Perry Nuclear Power Plant
Docket Nos. 50-440; 50-441
Control of Heavy Loads
Study Addendum

Enclosed are seven (7) copies of an Addendum to the Perry Nuclear Power Plant Control of Heavy Loads Study, Revision 2. This addendum adds the variable test weight which is used to calibrate the refueling platform interlocks. This test weight was added to the plant design after the Control of Heavy Loads Study was issued.

PERRY HEAVY LOADS STUDY

IMPACT AREA: COLUMN LINE (see Drawing 021-009)

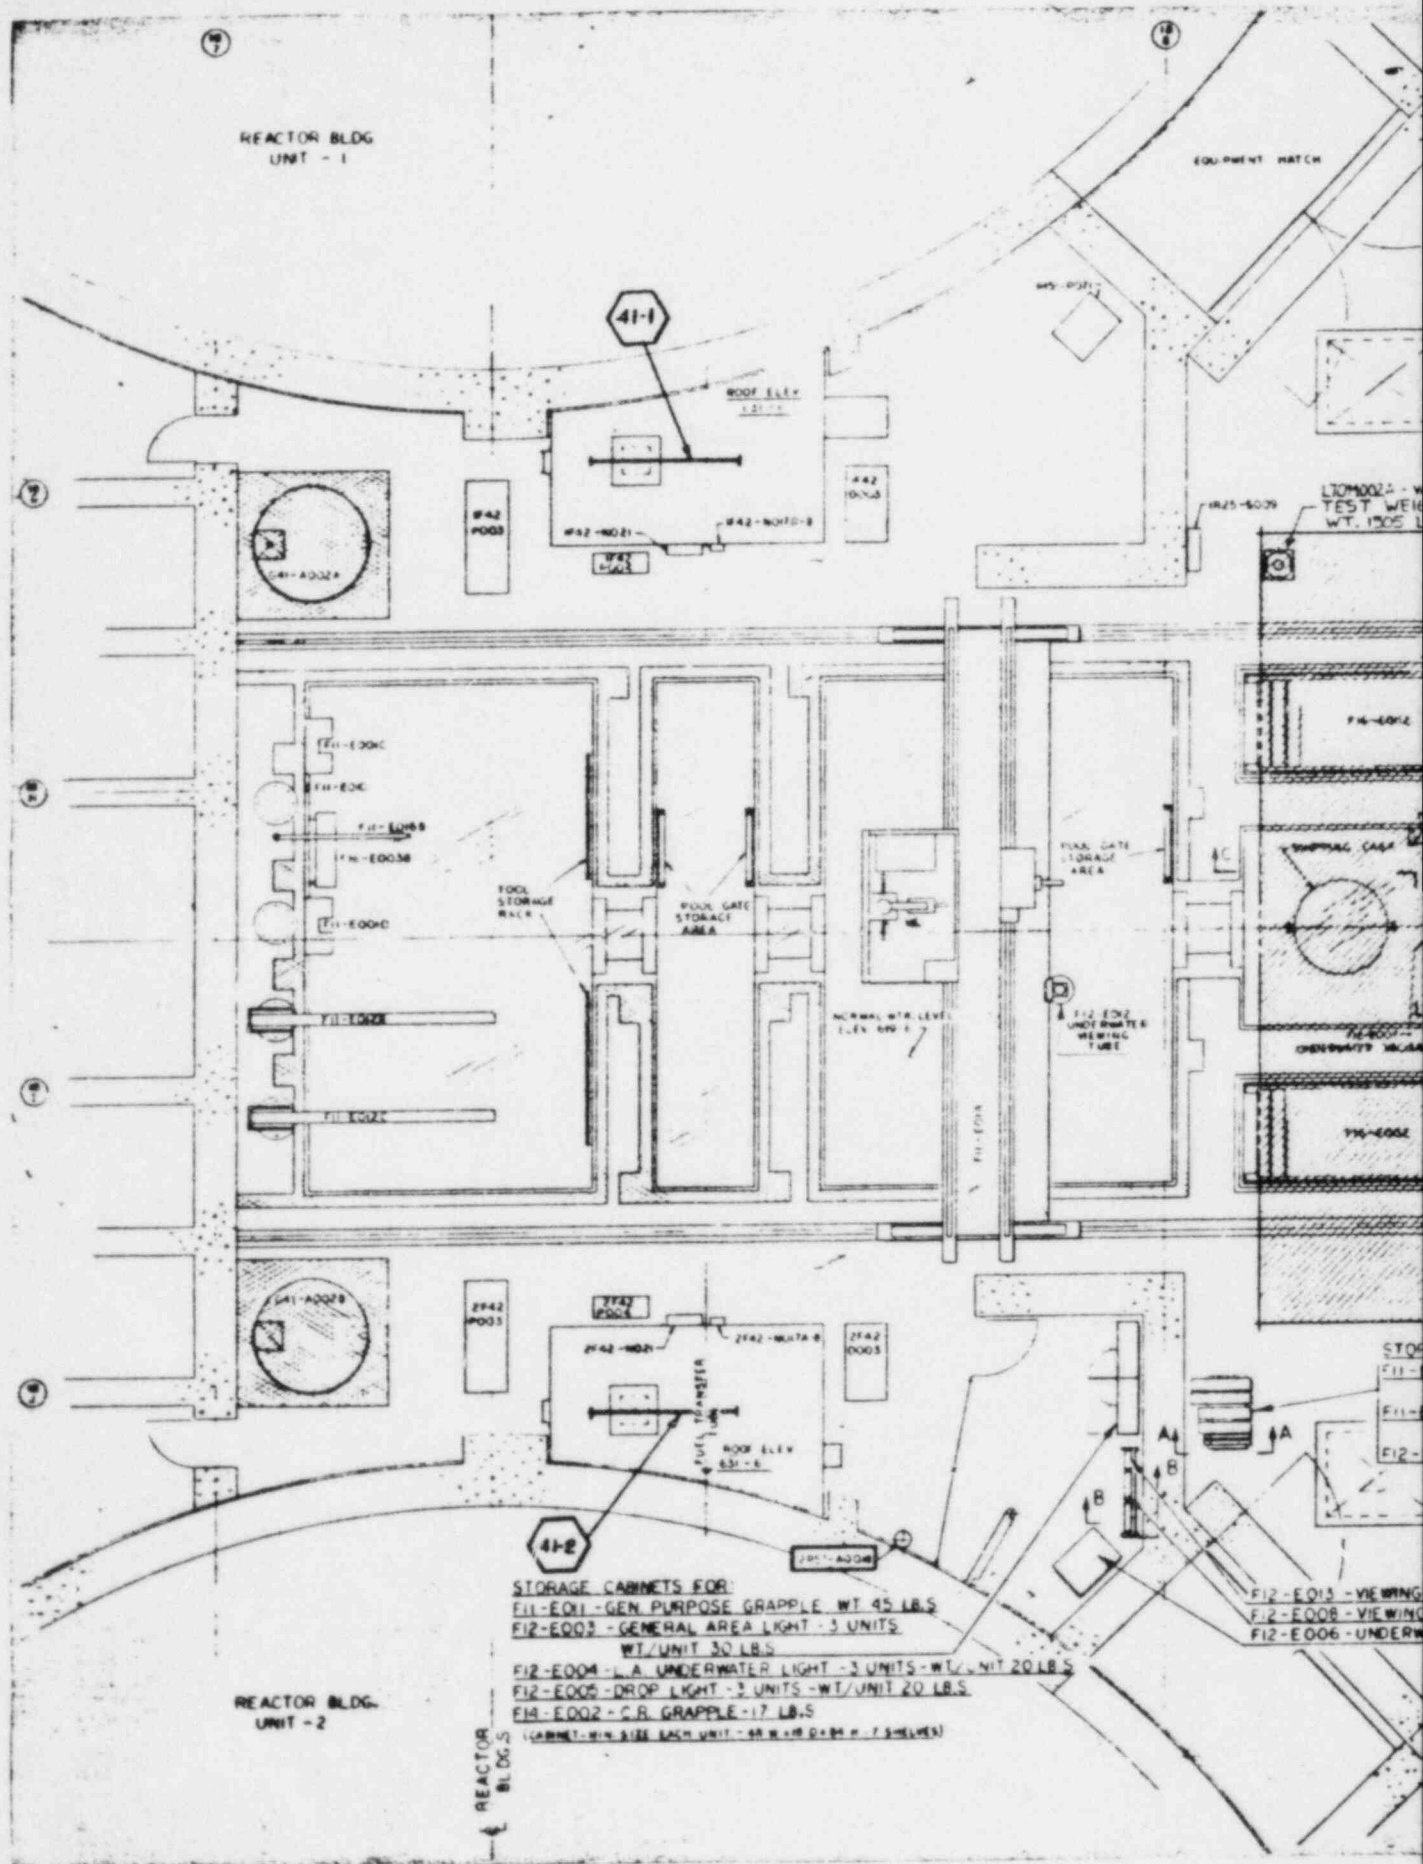
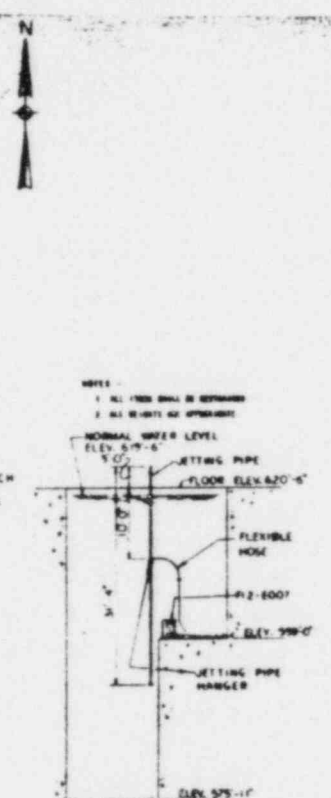
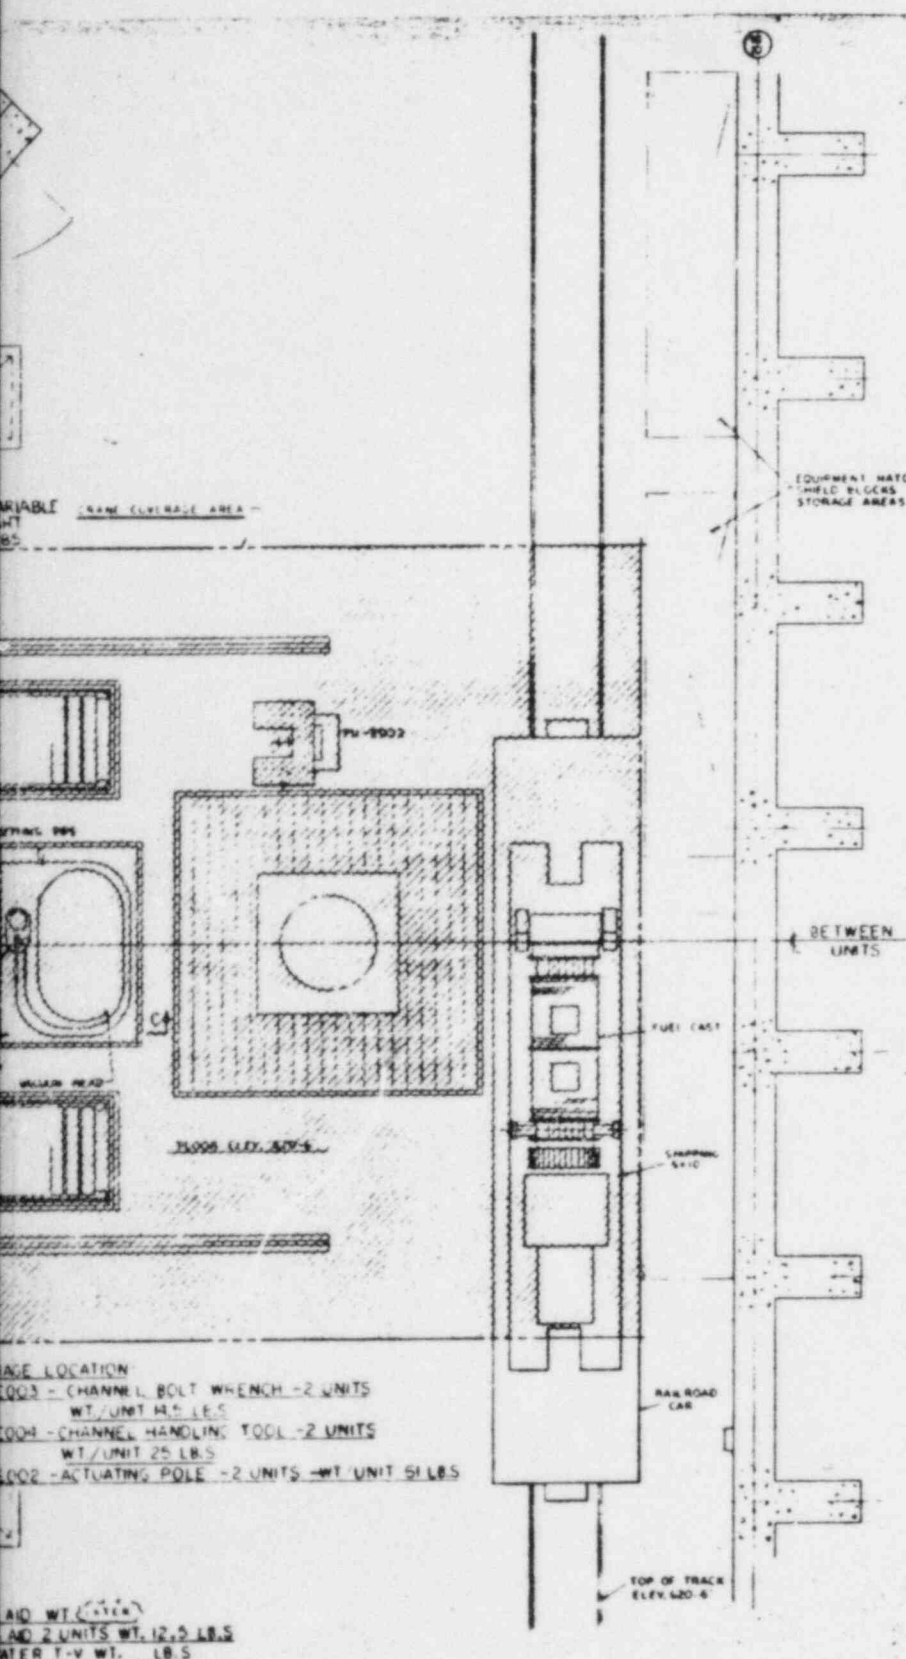
Load	Safety Related Equipment	Floor Elevation	Hazard Elimination Category	Remarks
10 & Variable Test 10A Weight 1,509 lbs.				1. Test Weight may require moving during any mode of operation.
	RHR (Loop B)	689'-6"	A	2. VTW is stored near header. If Loop B piping is damaged, Loop A can be used.
	Suppression Pool Make-up Piping - G43 (Loop B)	672'-0"	A	3. If Loop B piping is damaged, Loop A can be used.
	None	644'-7"	B	4. There is no safety-related equipment in the impact area at this elevation.
	RHR (Loop C) Piping - E12	617'-" to 630'-0"	A	5. If Loop C piping is damaged, Loop A or B can be used.
	None	599'-0"	B	6. There is no safe shutdown equipment in the impact area at this elevation.
	None	579'-0"	B	7. There is no safe shutdown equipment in the impact area at this elevation.
